**SUBDIVISION &
ZONING AMENDMENT STAFF REPORT****Date: April 18, 2019****APPLICANT NAME**

Griffith Subdivision, Addition

North side of Government Street, 140'± East of South Ann Street

SITE PLAN

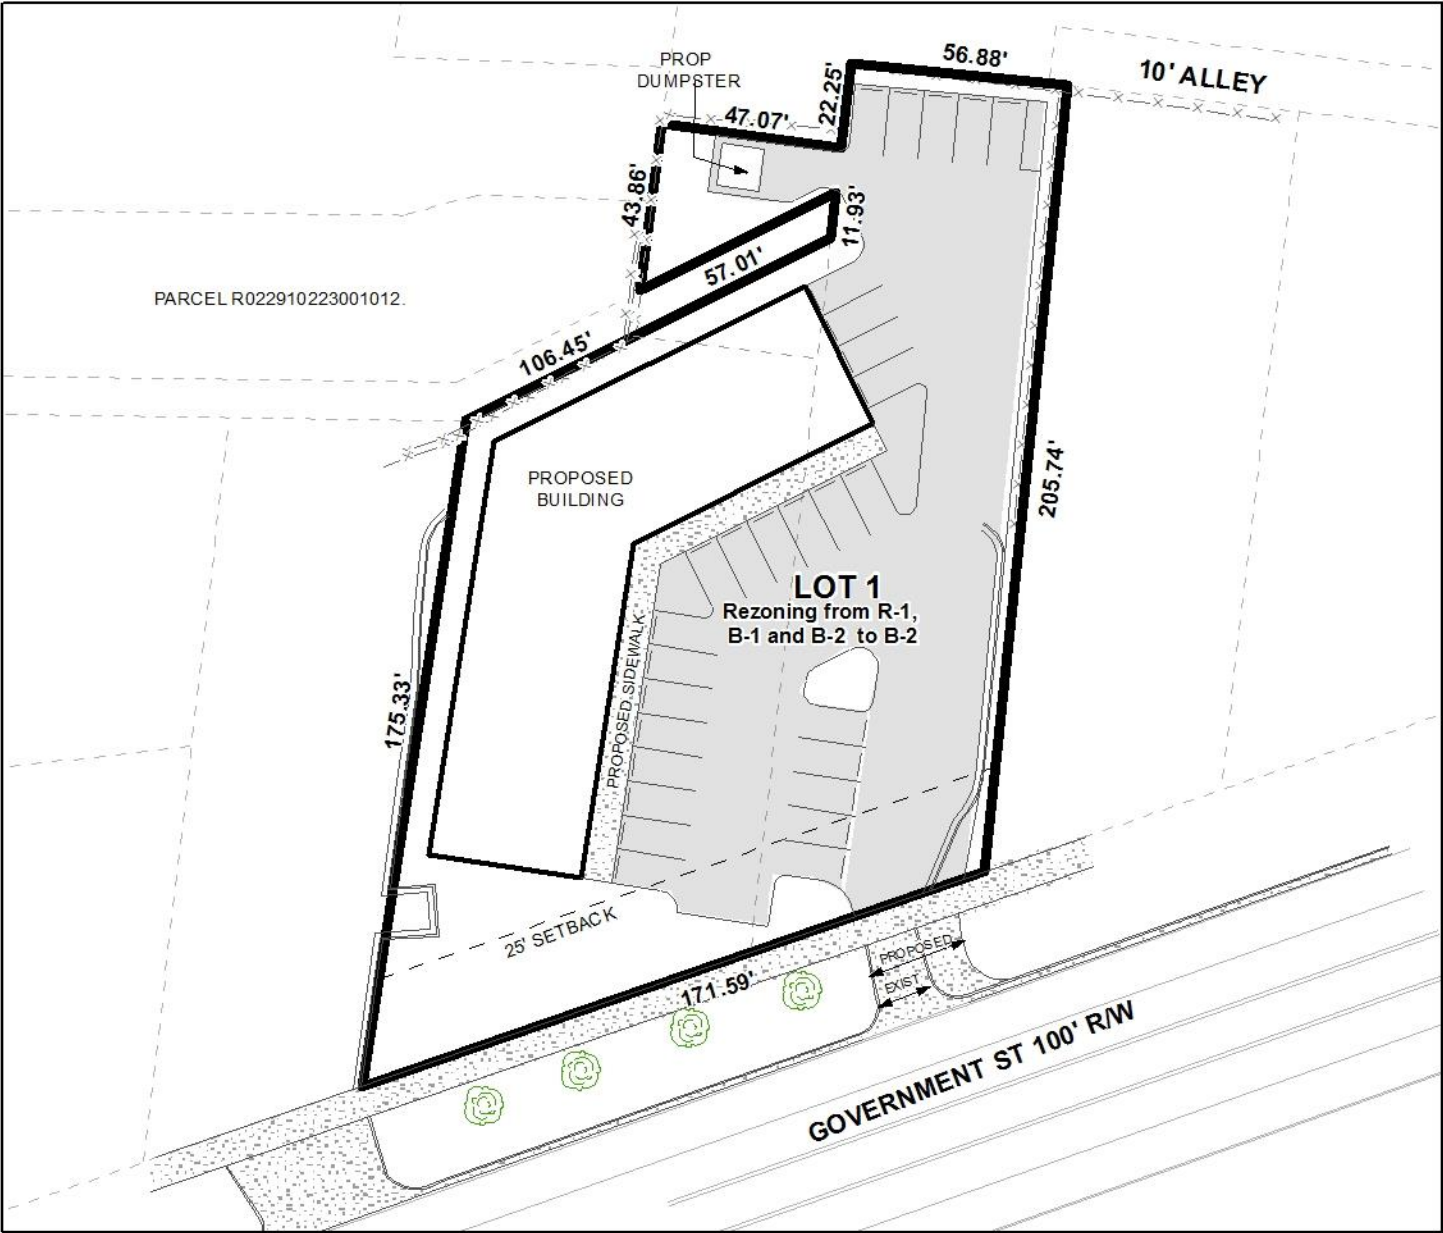
The site plan submitted by the applicant depicts a 7,154 square foot building with 27 parking spaces and a dumpster on site. However, it appears that there is no striped area next to the

handicapped space, which would result in the loss of one space. Furthermore, if all tenant spaces are occupied by retail, office, or “to-go” restaurants, 24 parking spaces would be required. This means that with the currently proposed site layout, no dine-in restaurants would be allowed. It should be noted that if the site is developed with more than 25 parking spaces, a photometric site plan will be required at the time of permitting.

In the applicant’s narrative, they state that existing shared access between the subject site and the property to the West will be closed as part of the redevelopment of the site. It should be pointed out that the site plan submitted shows an existing dumpster servicing the adjacent property on the subject site. In order for a new dumpster to be located on the adjacent property, a building permit will be required so that staff can make sure it meets the requirements of not only Planning & Zoning, but Plumbing.

DETAIL SITE PLAN

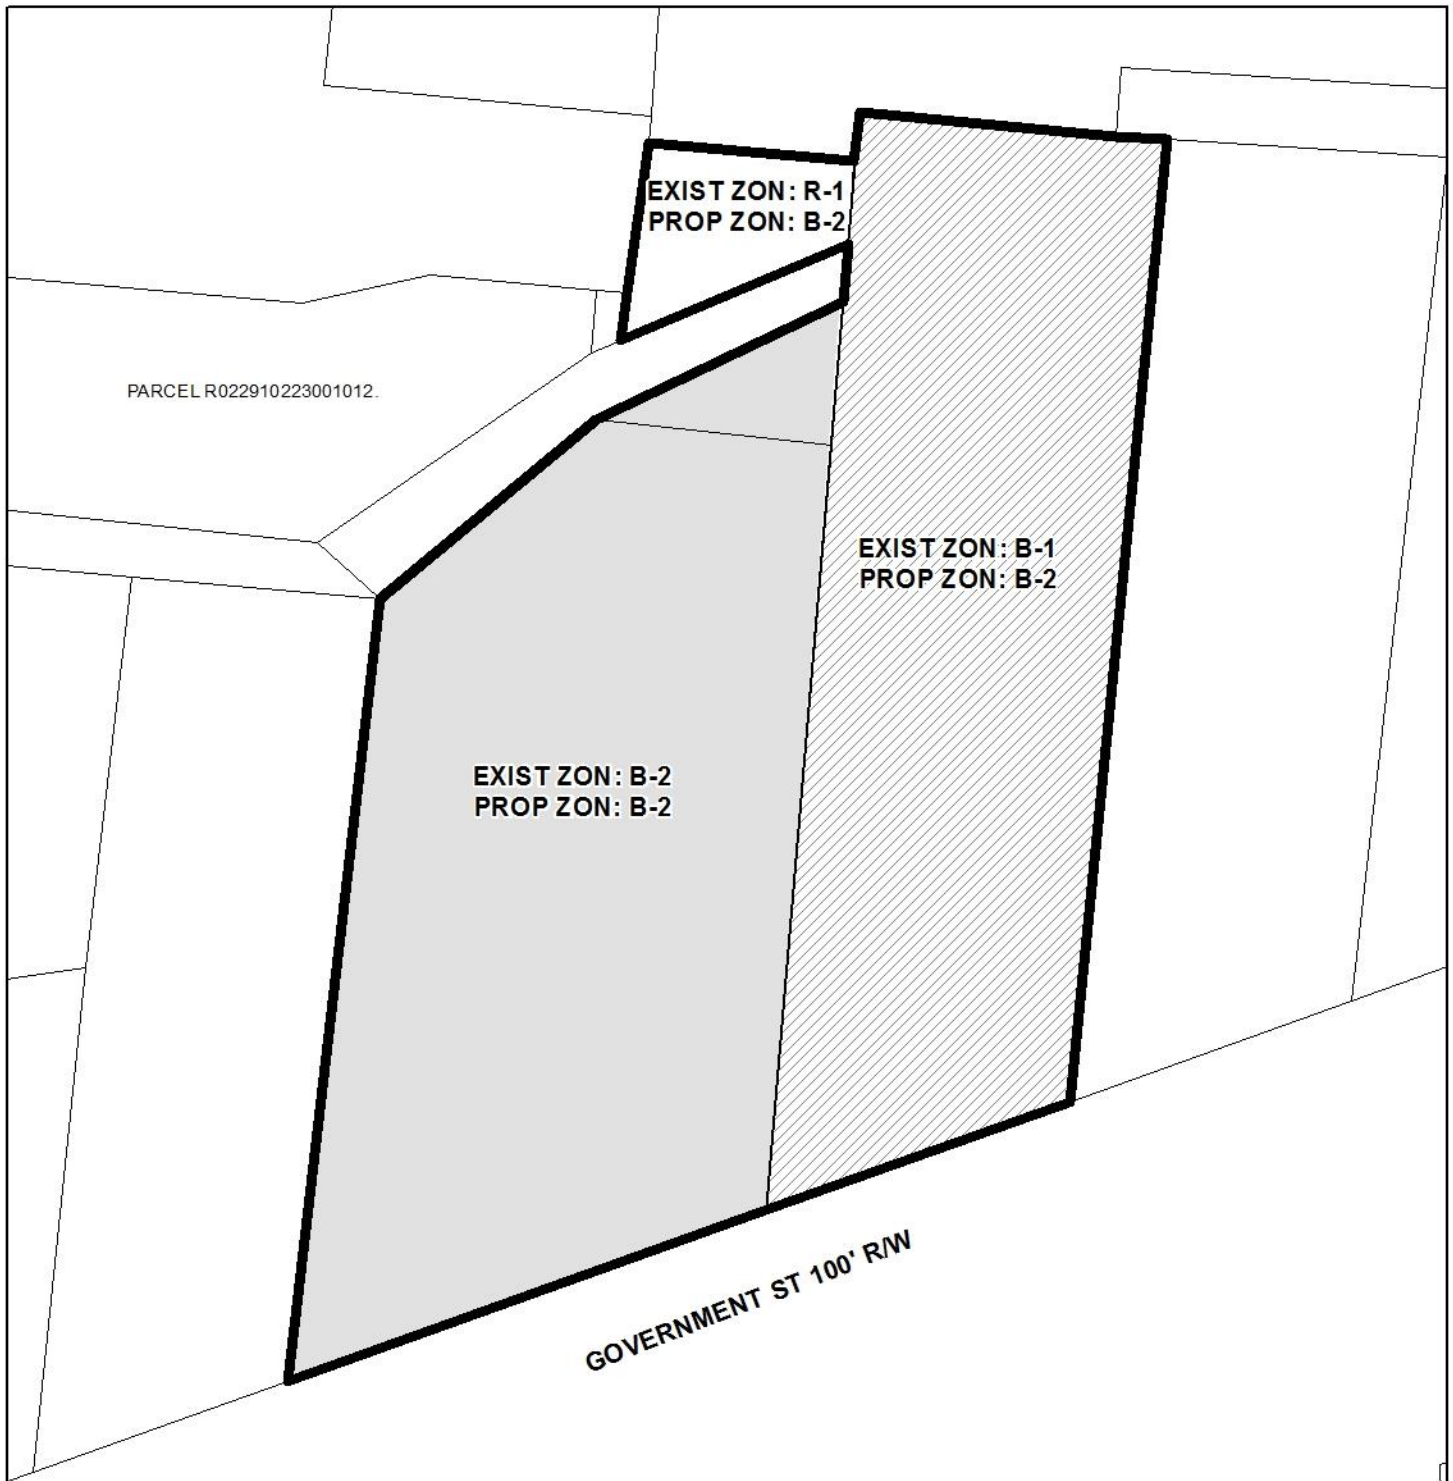
- A. Provide all of the required information on the SUBDIVISION PLAT (i.e. signature blocks, signatures, certification statements, written legal description, required notes, legend, scale, bearings and distances) that is required by the current Alabama State Board of Licensure for Professional Engineers and Land Surveyors.
- B. Check the ownership of a portion of the area labeled "10' ALLEY". It appears that it is privately owned.
- C. Clarify the area labeled "CLAIMED BY OTHERS". Only property owned can be subdivided.

- D. Provide and label the monument set or found at each subdivision corner. NIF (No Iron Found) is not appropriate.
- E. Provide the distance from the REF IS to the NIS point and to the two (2) NIF subdivision corners.

The applicant has submitted a revised preliminary plat and site plan. The portion of the property depicted as “claimed by others” has been removed from both the plat and site plan, however Parcel #: R022910223001012 was not included, nor was Lot 2 of Griffith Subdivision excluded. Due to the previously mentioned note on the 1987 plat stating “Lot 2 of Griffith Subdivision to be used only in conjunction with Lot 3, W.T. McGowin Property as per map or plat by A.S. Towle, deed book 127 N.S., page 383.”, and as neither the entirety of Lot 3, W.T. McGowin Property was included, or consent from the owner of Lot 3 provided, the Planning Commission cannot approve the applications as proposed.
